Minor Development Staff Report

SUBJECT: RIVER CANYON FILING 2, 4TH AMENDMENT – MINOR DEVELOPMENT PLAT

PROJECT FILE: SB2024-019

DATE OF PREPARATION:	03/19/2024
SCALE:	1" = 30'
SHEET 3 OF 3

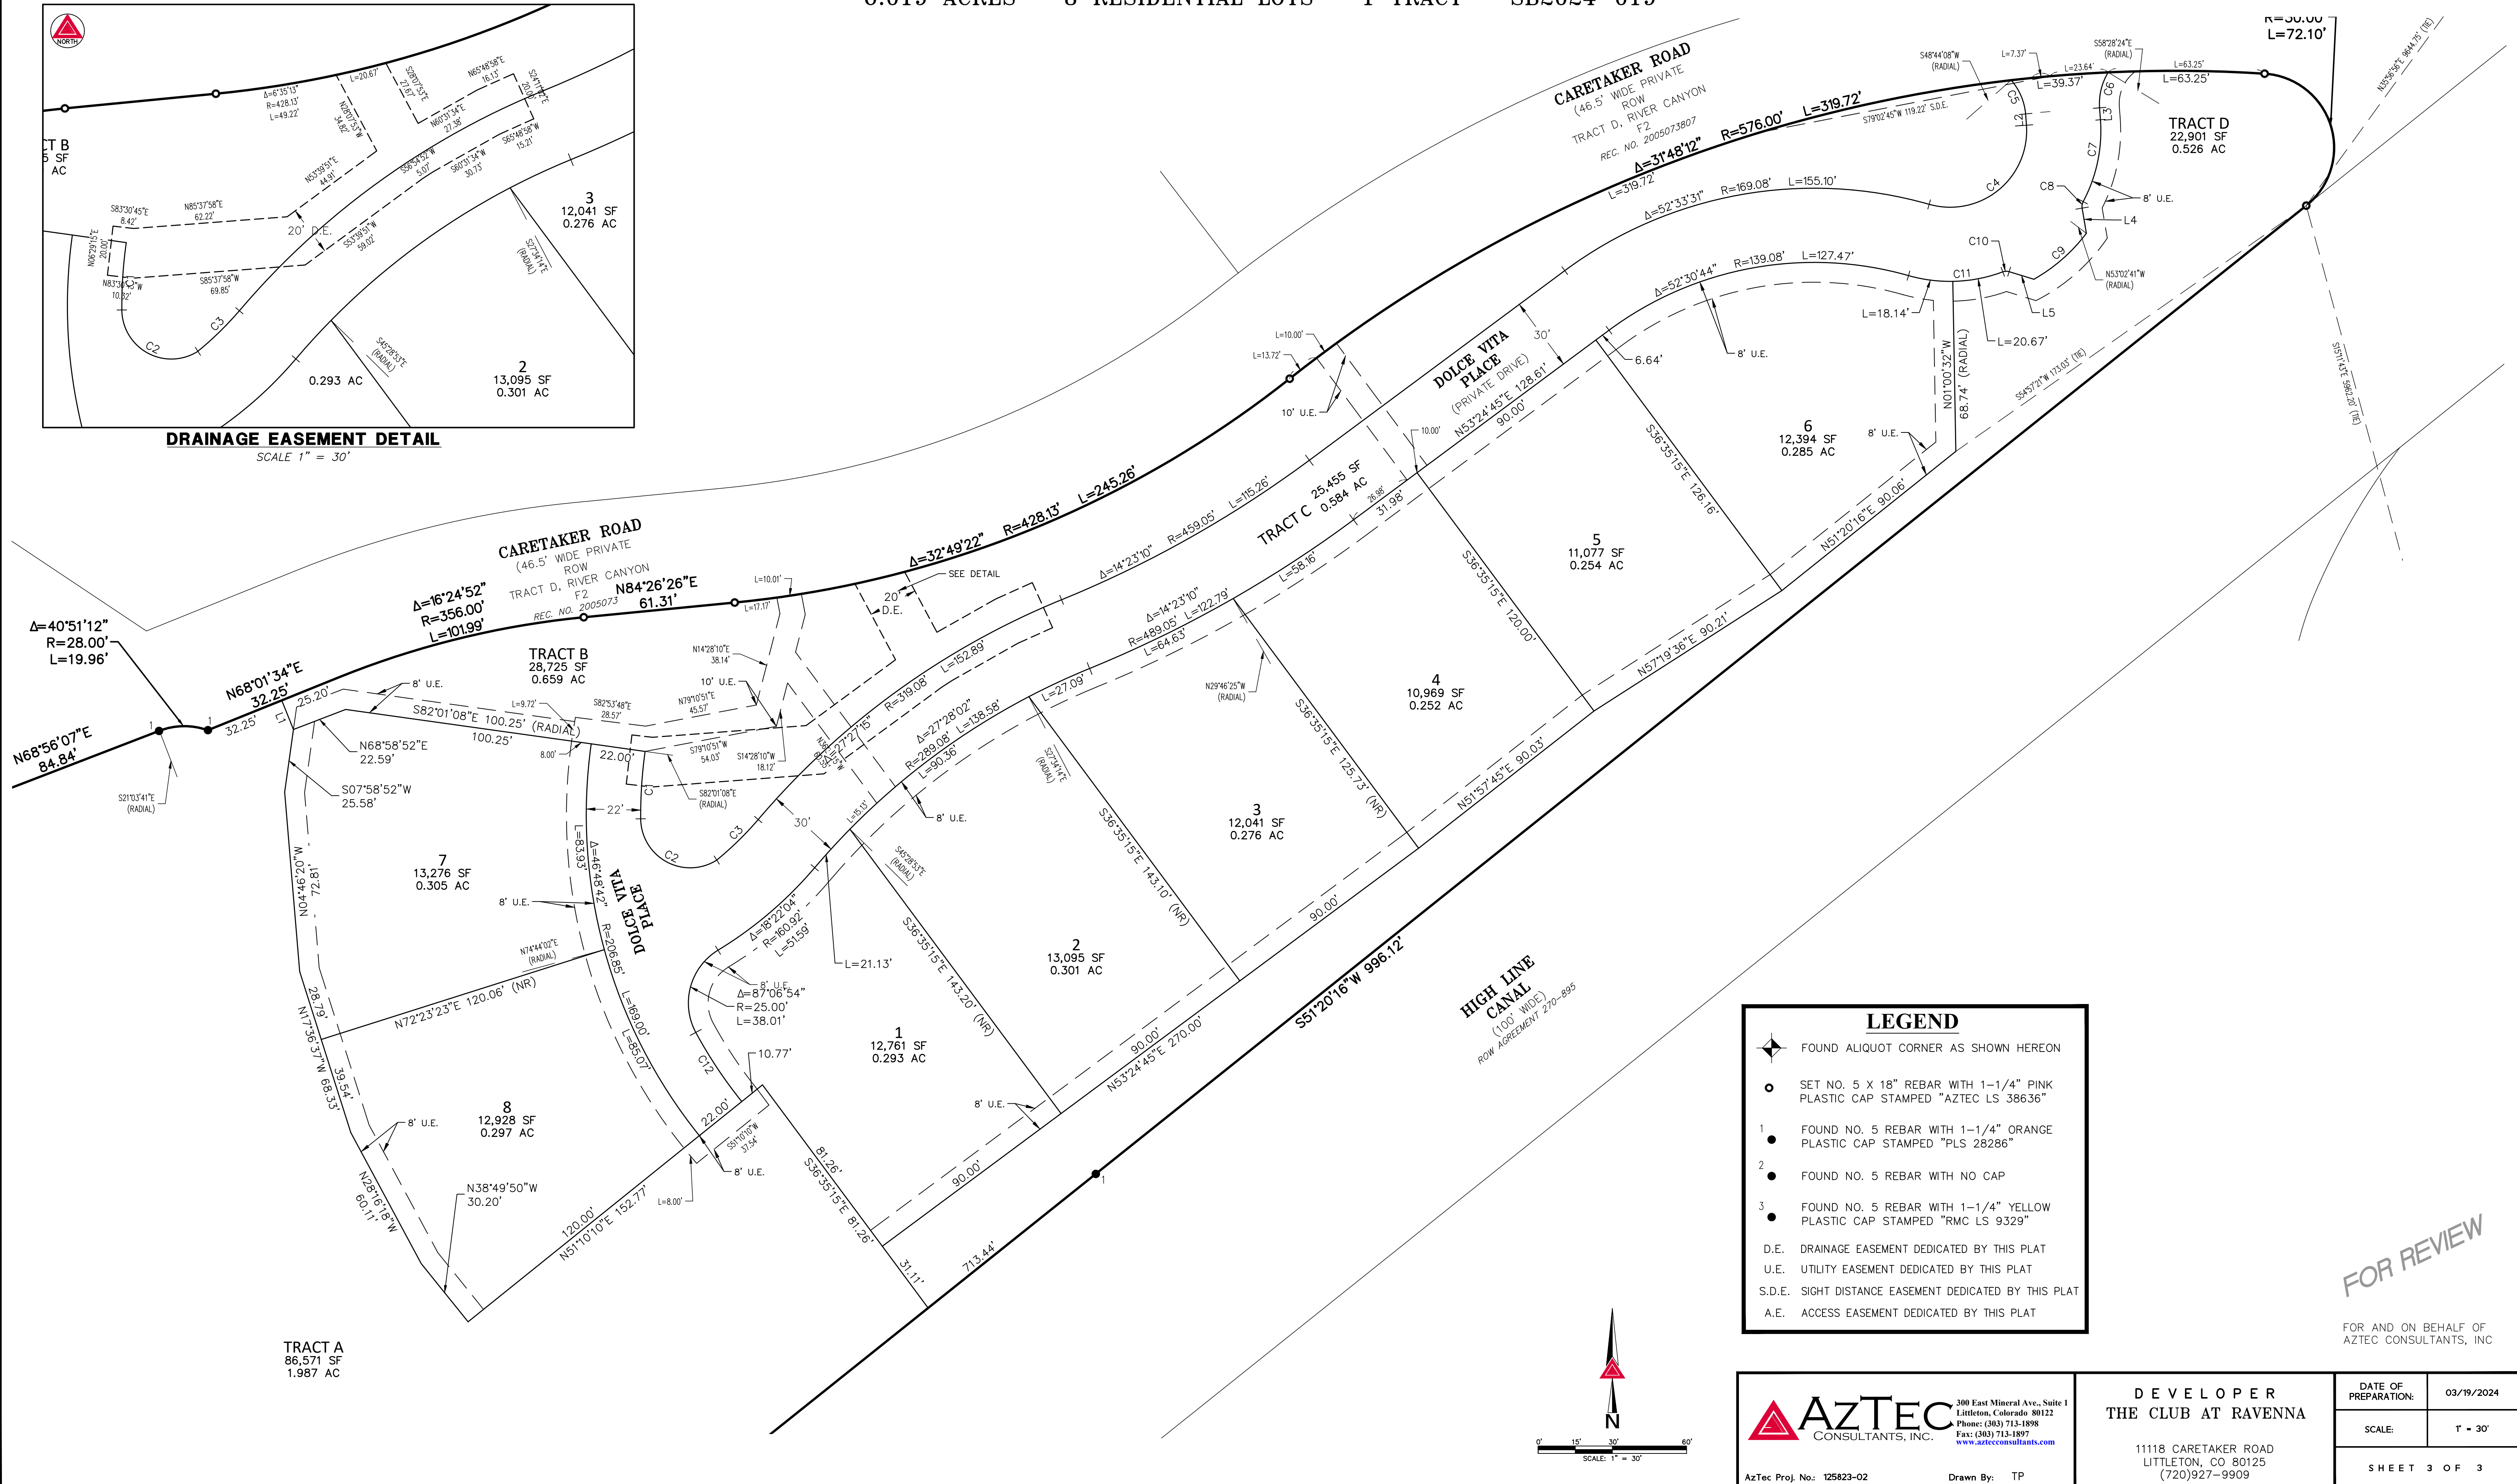
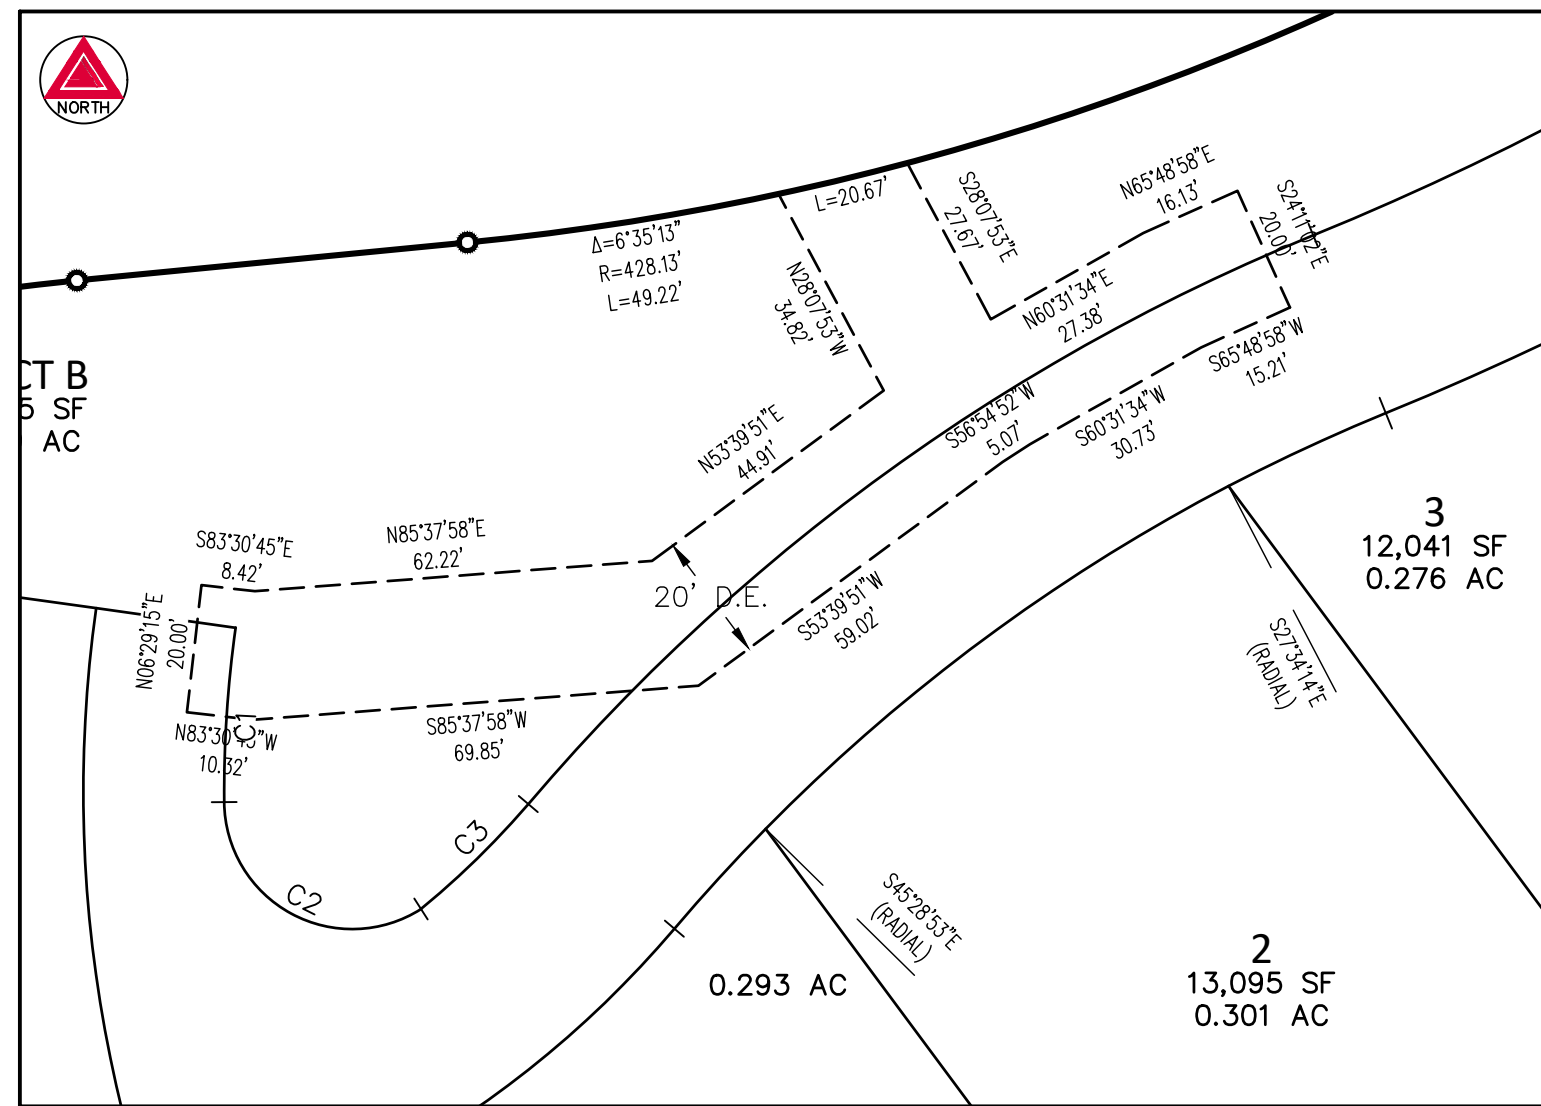
Response: Sight distance easement has been shown and dimensioned on sheet 3 of the plat. In the past with Douglas County we have only had to specify 24" instead of 36". We have added a note saying the following "no object within the sight distance easement shall be more than twenty-four (24) inches above the flowline of the adjacent street"
